Applicability of GE Methods to Expanded Operating Domains- Supplement for GNF2 Fuel NEDO-33173 Supplement 3-A Revision 1, July 2011

NEDO-33173
Supplement 3-A
Revision 1
DRF 0000-0012-1297
DRF Section 0000-0129-0237-R0
July 2011

**Applicability of GE Methods to
Expanded Operating Domains -
Supplement for GNF2 Fuel**

SUBJECT: FINAL SAFETY EVALUATION FOR GE HITACHI NUCLEAR ENERGY
AMERICAS TOPICAL REPORT NEDC-33173P, SUPPLEMENT 3,
"APPLICABILITY OF GE METHODS TO EXPANDED OPERATING DOMAINS –
SUPPLEMENT FOR GNF2 FUEL" (TAC NO. ME1815)

Figure 4-1 - Per Cent Difference Between 5% Bypass Void Pin Power and No Bypass Void Pin Power – GNF2 Design

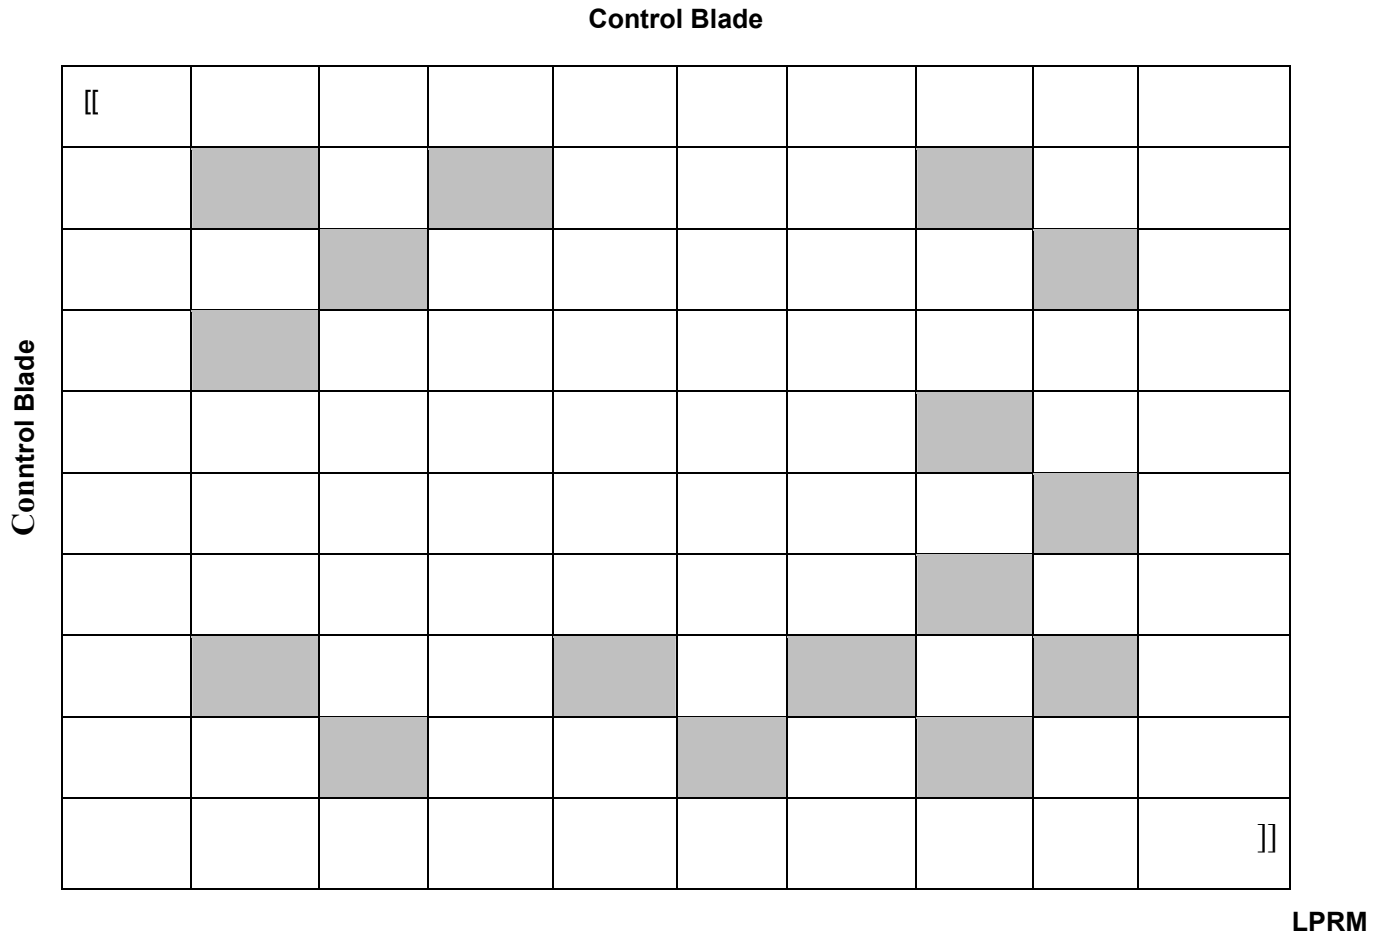
Figures 4-1 and 4-2 show the percent change in rod peaking due to 5% bypass and water rod void fraction for the GE14 and GNF2 lattice as a function of position in the lattice. The wide gap location is denoted by the words “control blade” in the figure and is only there to locate the position of the control blade part on the interchannel gap. All calculations are performed in the uncontrolled configuration. The gadolinium rod locations are shaded grey and the top six peaking locations in the upper right half of the lattice are identified by bold, italic font. (The peaking in the lower left half is symmetric with the upper right half.)

Figure 11-1. Illustration of the BSP Controlled Entry Regions and Base Scram Region

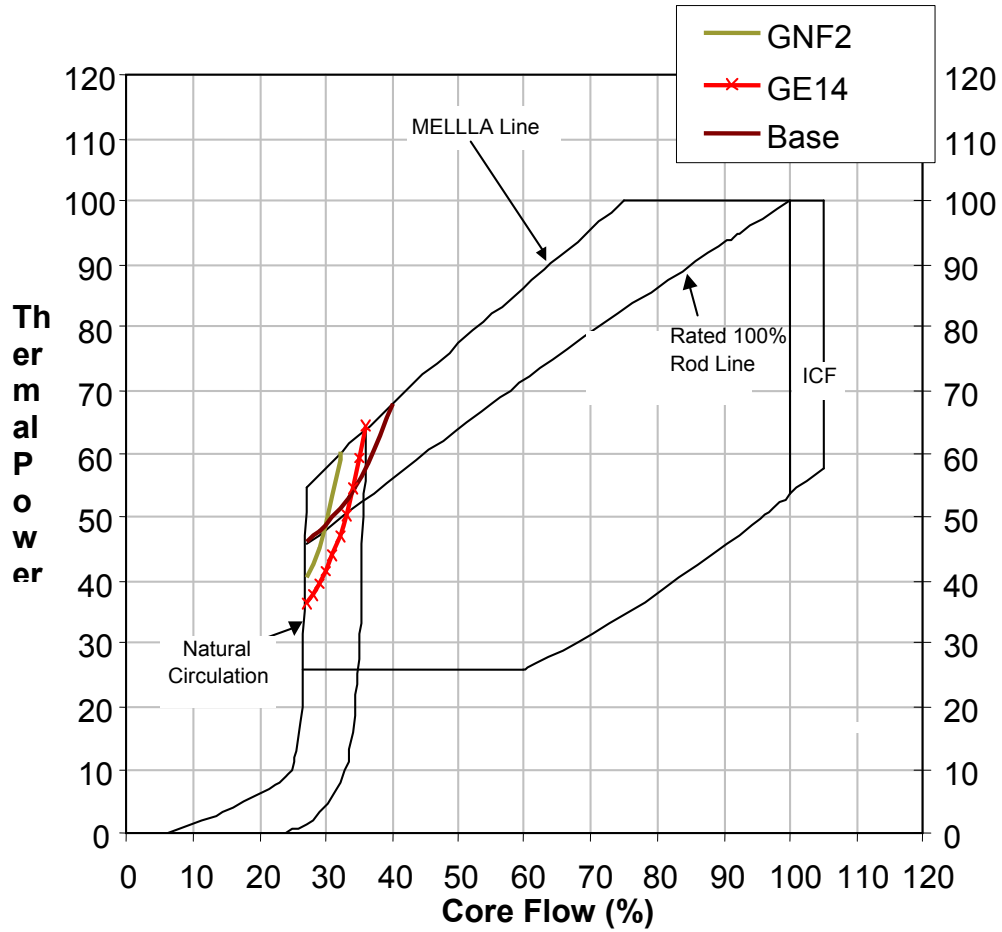
The Base BSP Scram Region with the GSF option is also illustrated in Figure 11-1. Hence, the size of the Controlled Entry Region is also limited by the Base BSP Scram Region.
